UNITED STATES PATENT AND TRADEMARK OFFICE

10/518,194

Office Action Summary	Application No. 10/518,194	Applicant(s) NOMURA ET AL.	
	Examiner EDNA WONG	Art Unit 1795

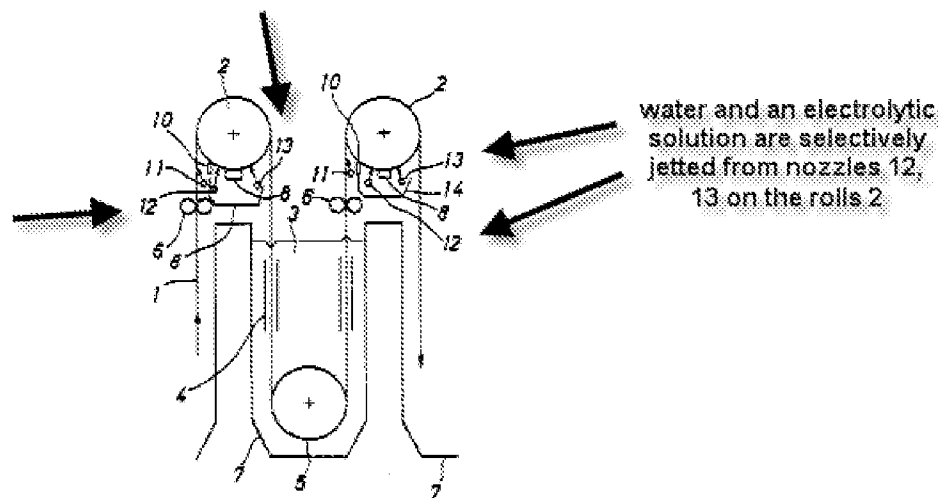
As shown in Fig. 1 of JP '492, water and an electrolytic solution are selectively jetted from nozzles **12, 13** on the rolls **2**:

By the positions of the nozzles **12**, **13**, it appears that the jetted electrolytic solution would have been attracted to the surface of the conductor roll **1** and provided a thin film of electrolytic solution between the surface of the roll and the metallic strip **1** to some degree.
